Manly2015 Master Plan and the Manly Oval Car Park

Submission to Manly Council regarding estimated costs for the project and the risks that appear not to have been properly considered in the development of the likely outturn cost and the subsequent assessment of the Project's viability.

Manly2015 Master Plan and the Manly Oval Car Park - Submission regarding estimated costs and risk profile

Figure 2 - Diaphragm Wall construction (courtesy Bachy-Soltenache)

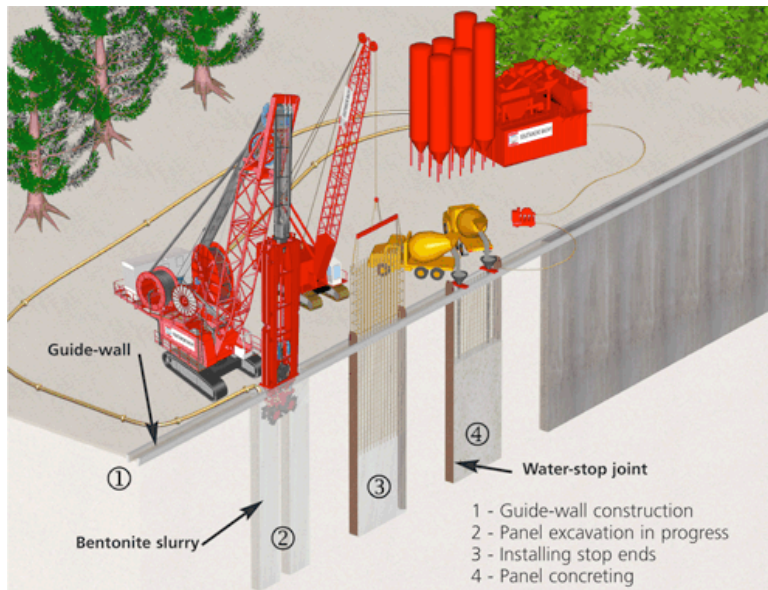
Diaphragm walls are constructed from the surface prior to any excavation and extend to a significant depth below the proposed floor of the excavation. The wall serves two purposes: firstly, it retains the sand behind the wall (on the non-excavation side), and secondly, by extending well below the base of the excavation, it provides a tortuous path for the ground water to infiltrate the excavation, thereby slowing the rate of infiltration to the excavation and minimising pump-out requirements and water table draw-down on the other side.

Figure 2 is a schematic showing the construction of a diaphragm wall (from Bachy-Soltenache website). The size and spread of equipment can be gauged from the scale of the concrete transit mixers in the sketch.

- A large crane mounted cutting rig will excavate slots to the design depth, replacing the excavated material with a slurry that will ensure the walls of the excavation do not collapse.
- Following completion of excavation, a crane will lower prefabricated steel reinforcement cages into the slurry-filled slot.
- Stage 3 involves the placement of concrete into the slot. As the concrete is pumped into the slot, it displaces the slurry, which is subsequently “cleaned” and reused.
